# DANE COUNTY DEPARTMENT of PUBLIC WORKS, HIGHWAY and TRANSPORTATION

RFB NO. 313086 - ADDENDUM NO. 3

### ARCTIC ANIMAL EXHIBIT AND CONCESSIONS

**CS1.0**

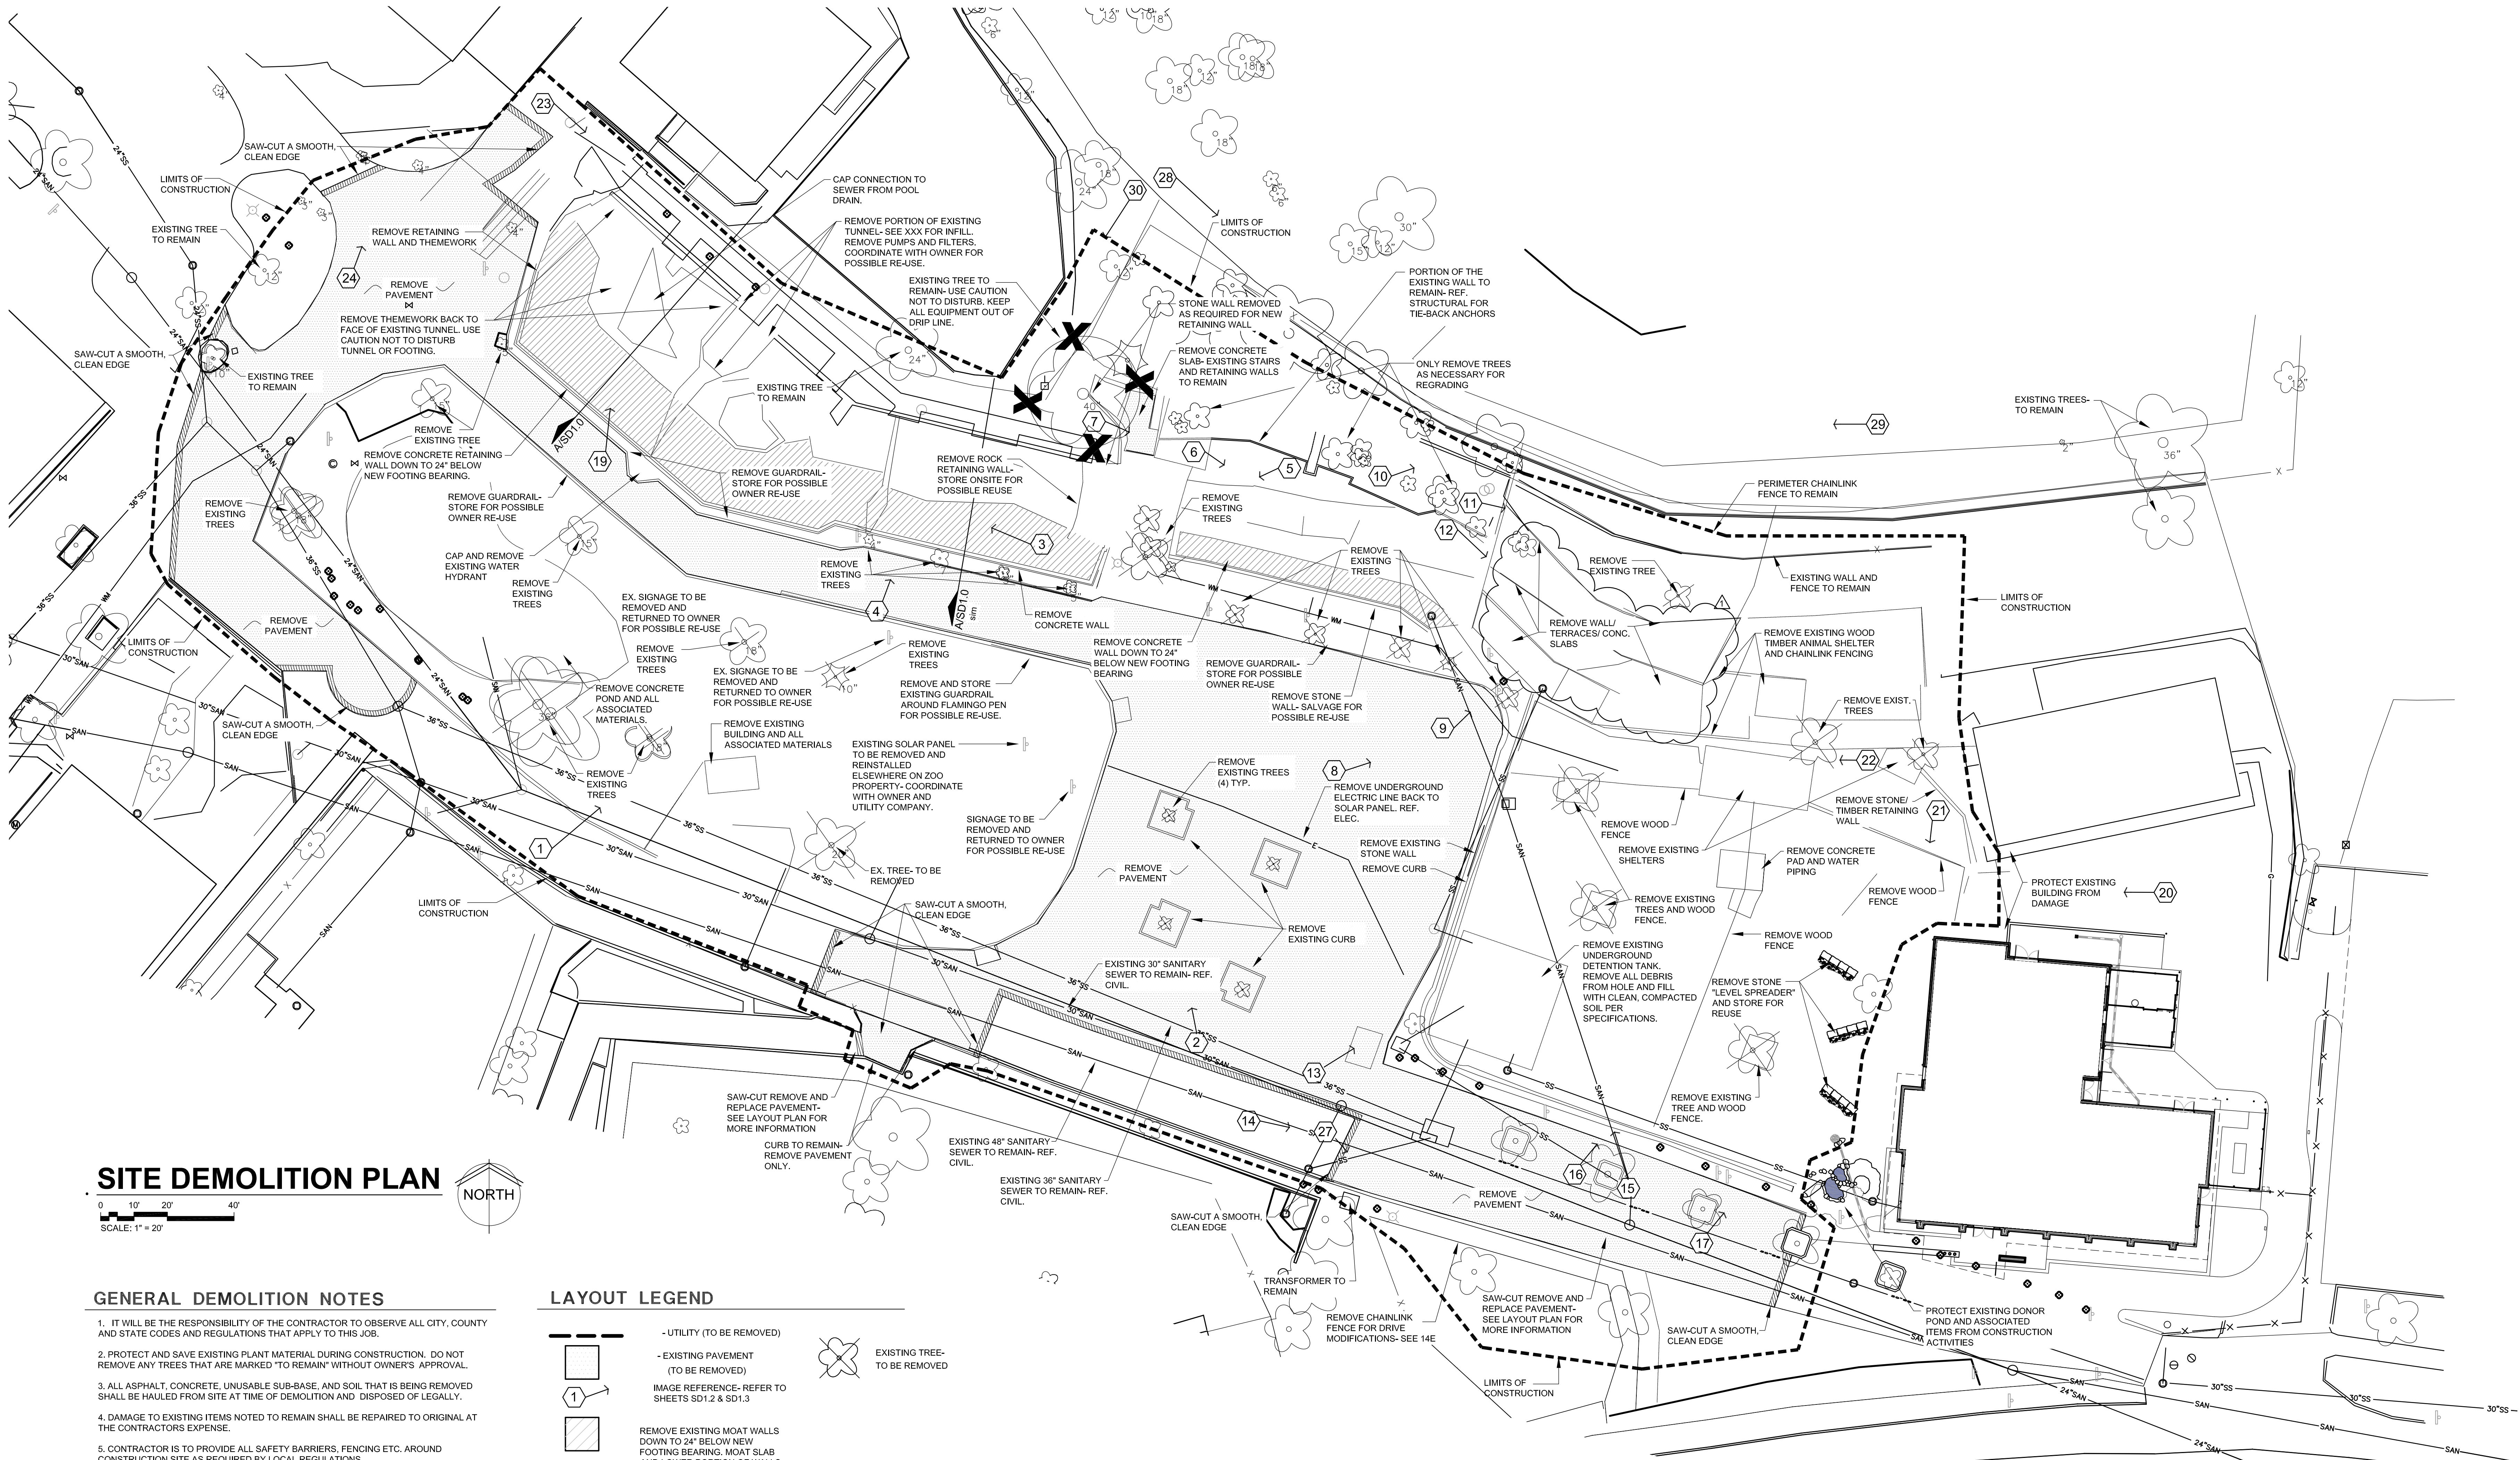
Modifications to temporary zoo perimeter fence in area of administration building, as well as by maintenance and animal health center buildings. Delete current Sheet CS1.0; replace with new Sheet CS1.0, issued with this Addendum.

**SD1.0**

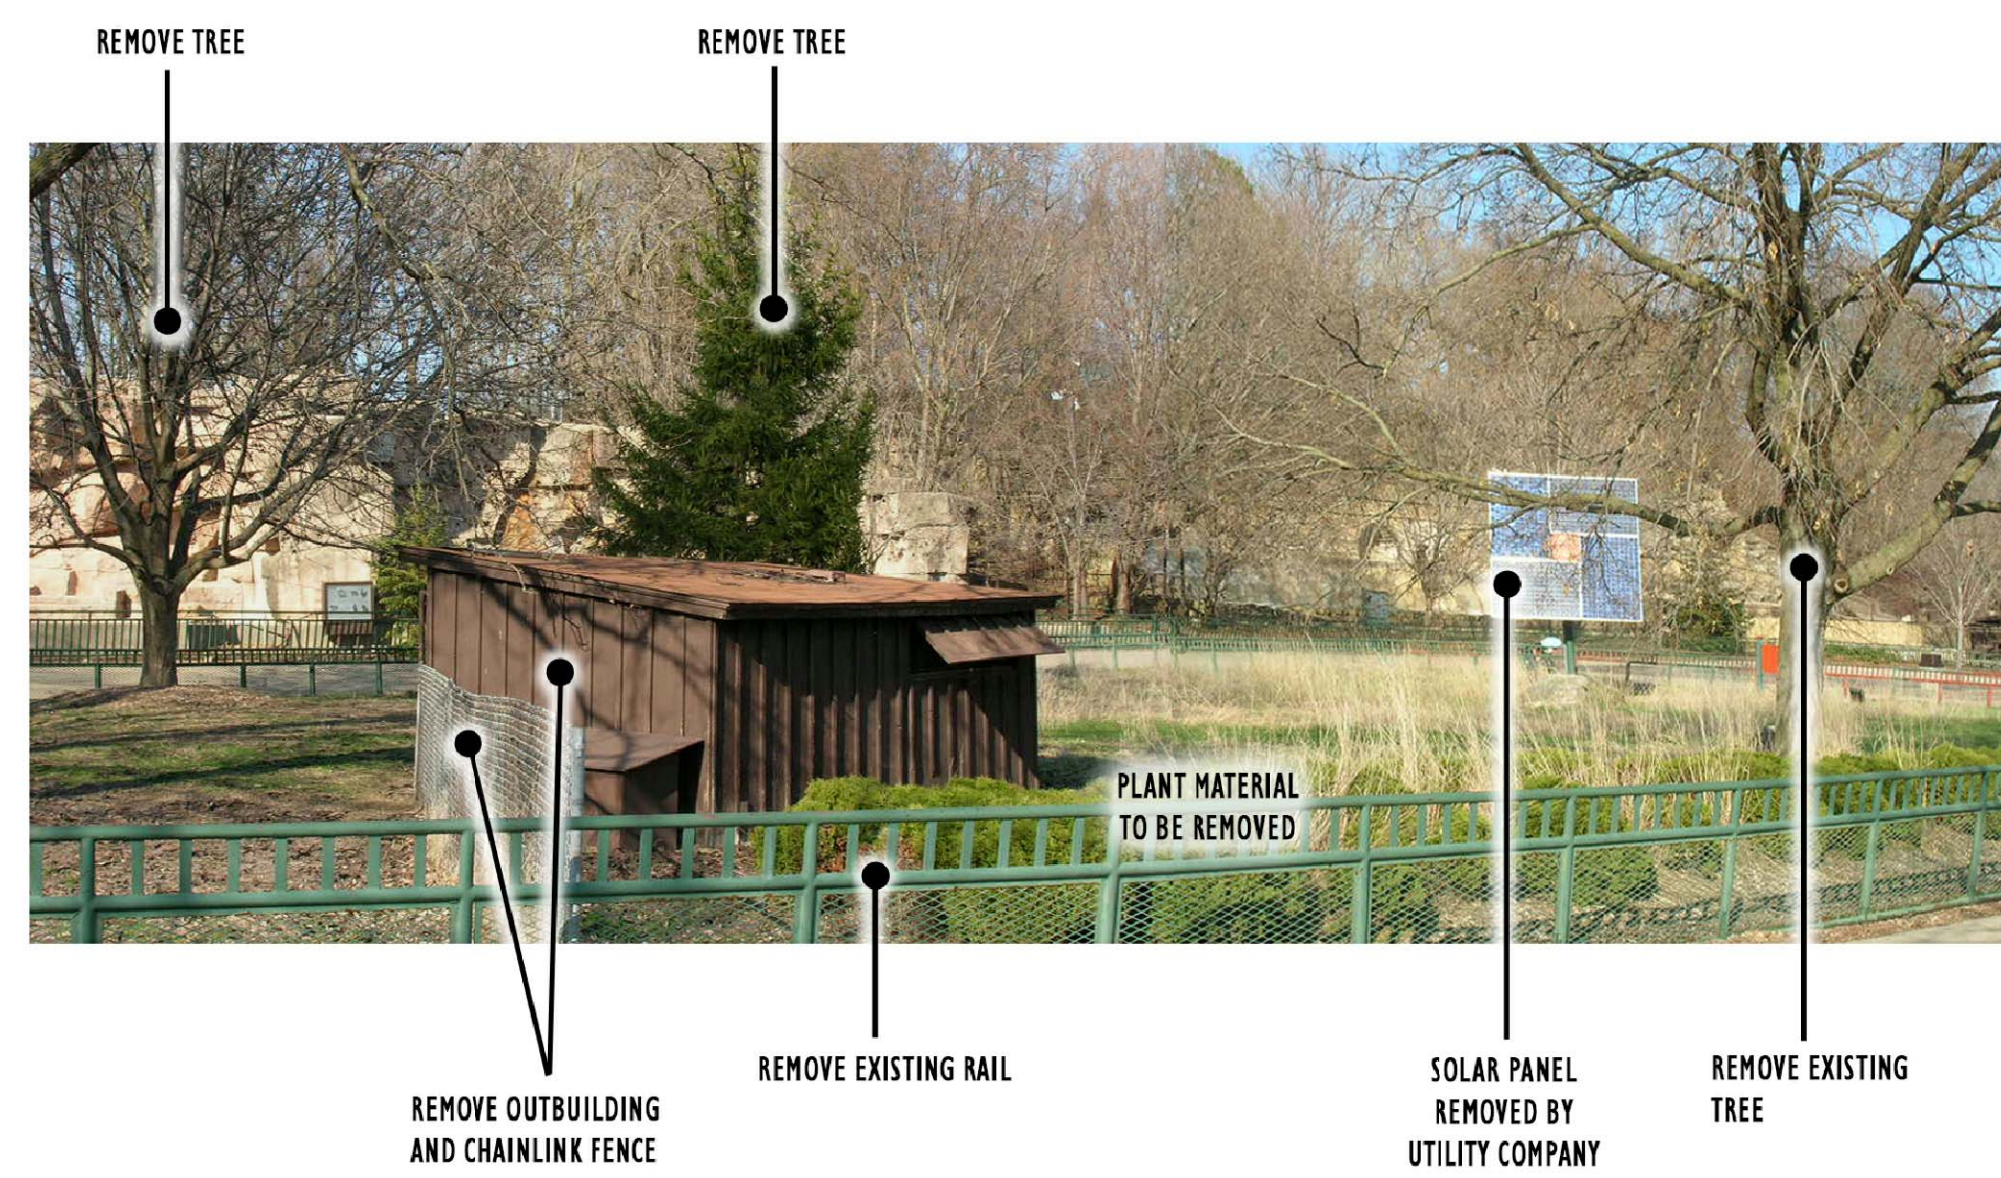
Modified demo notes at north east portion of site. Delete current sheet SD1.0; replace with new Sheet SD1.0, issued with this Addendum.

SD1.1

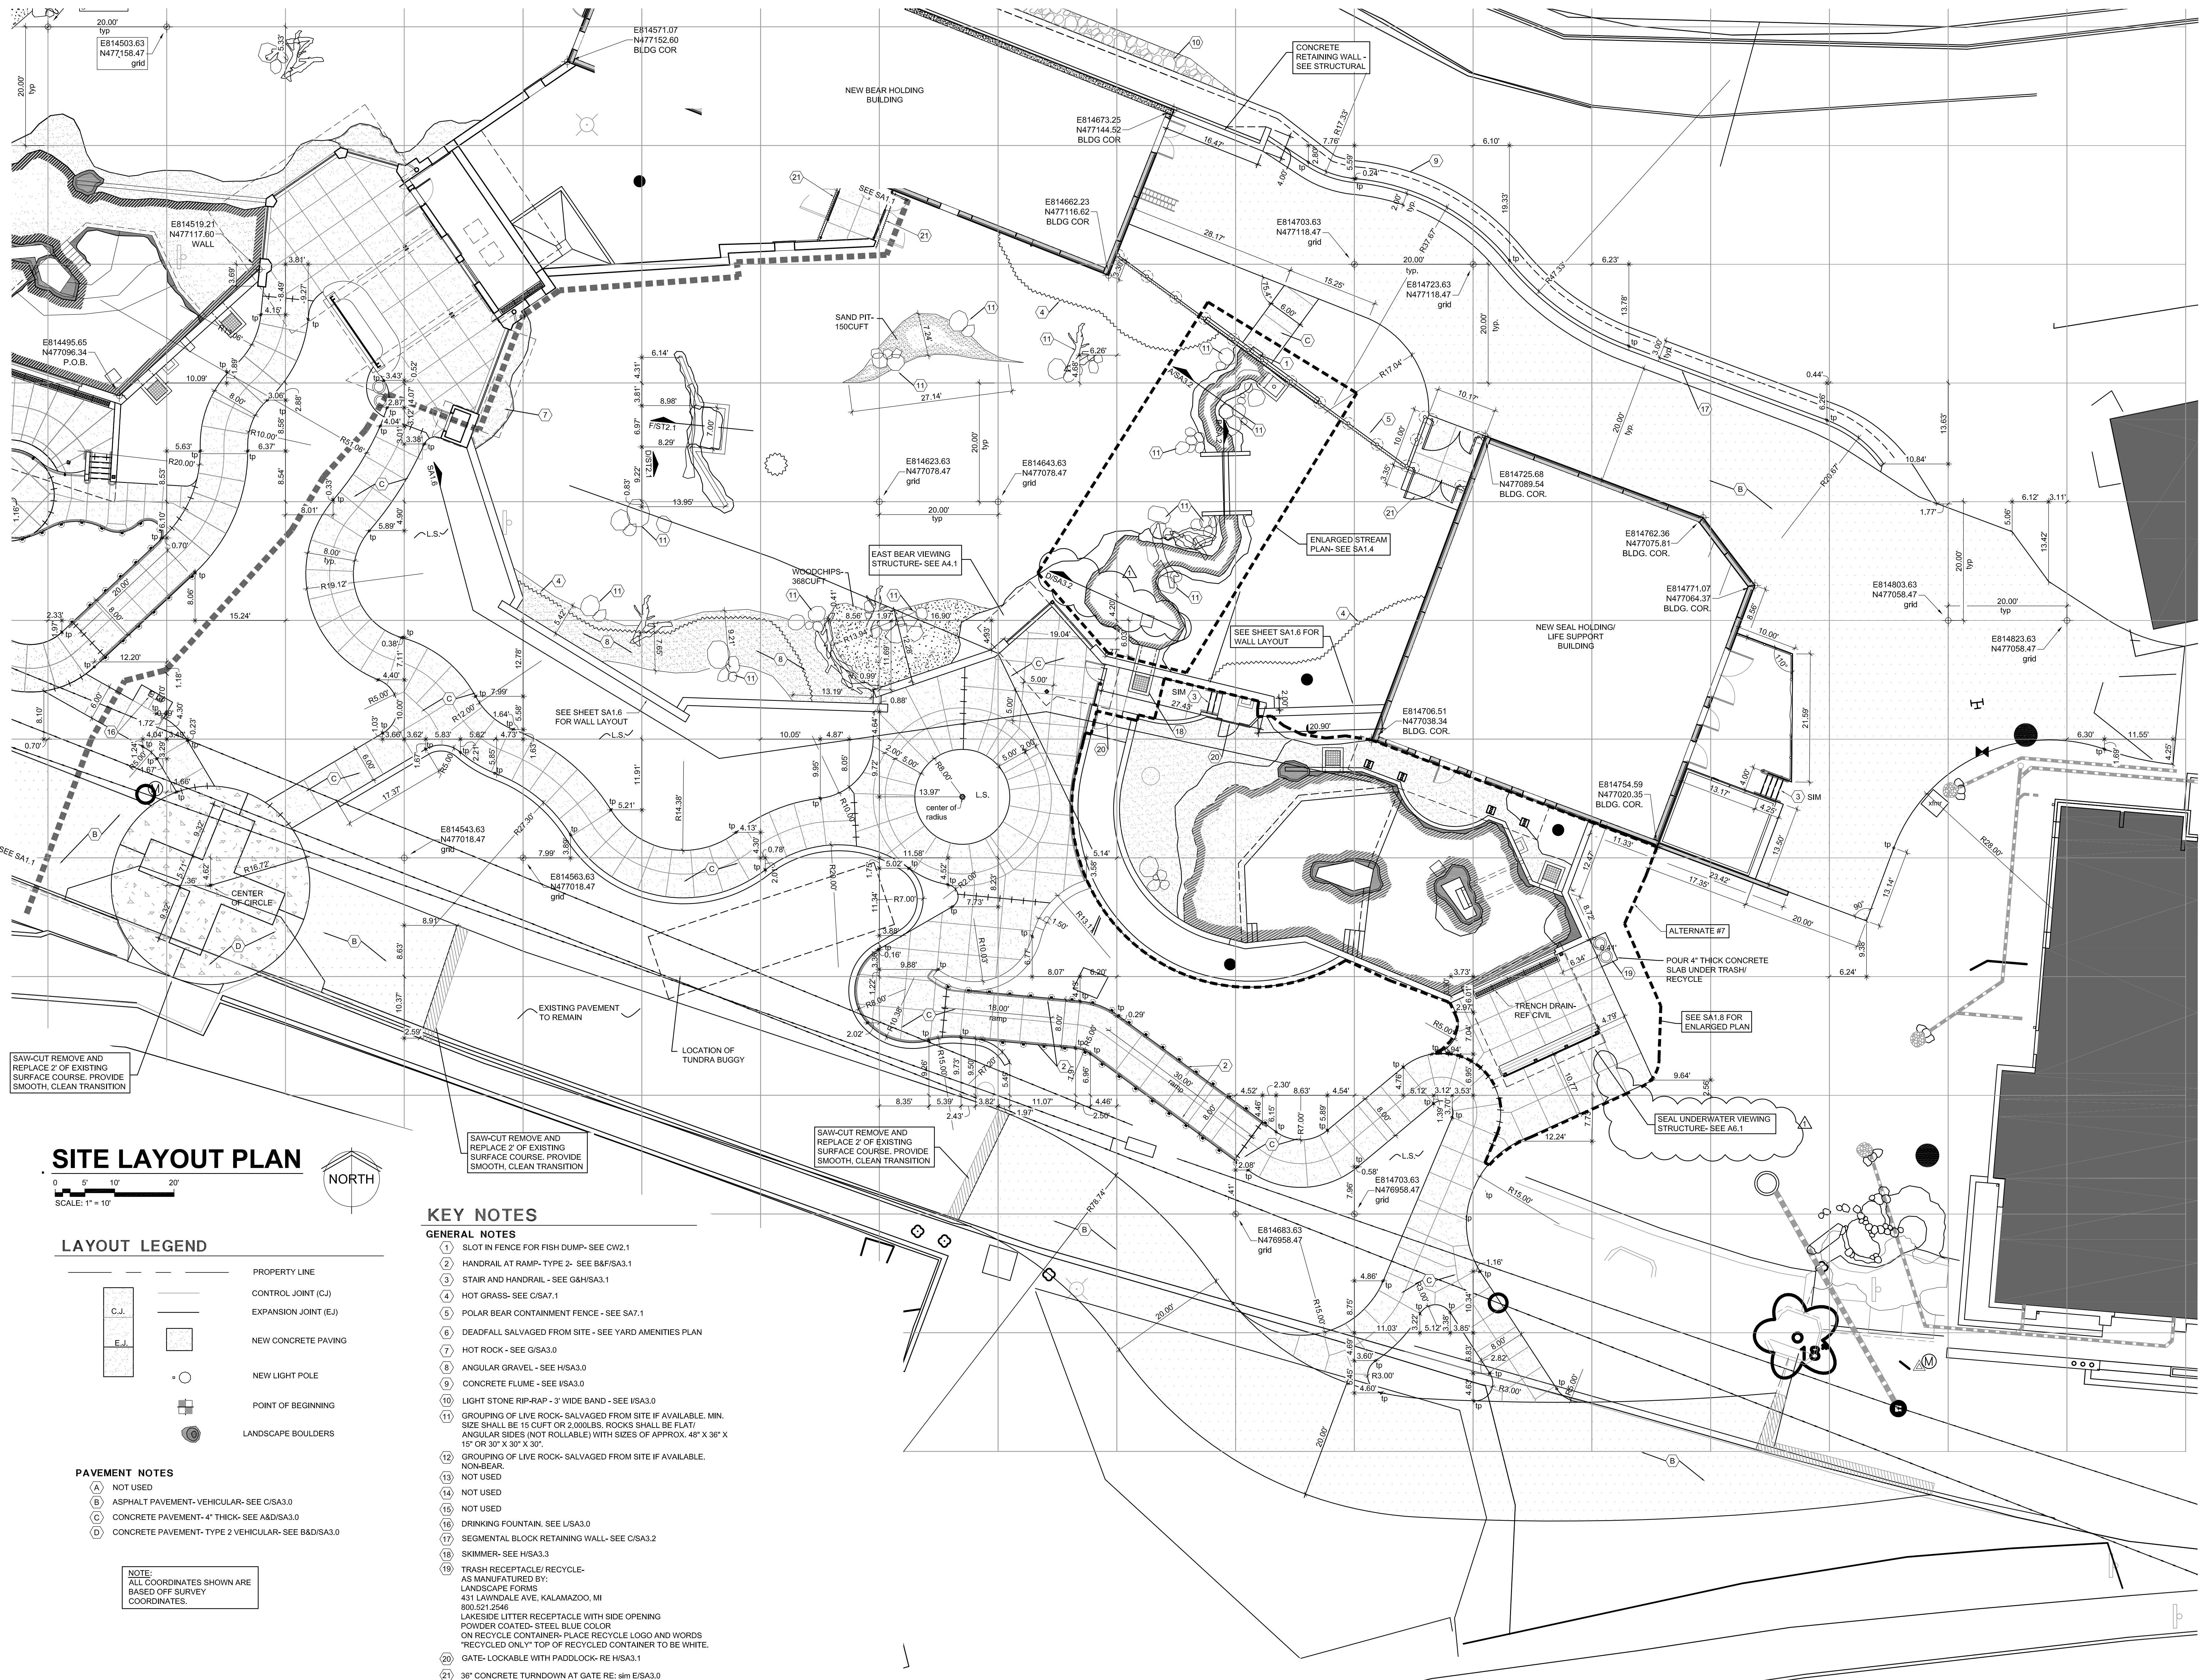
Updated notes on images 5, 6, 7, 10, 11, & 12. Delete current sheet SD1.1; replace with new Sheet SD1.1, issued with this Addendum.
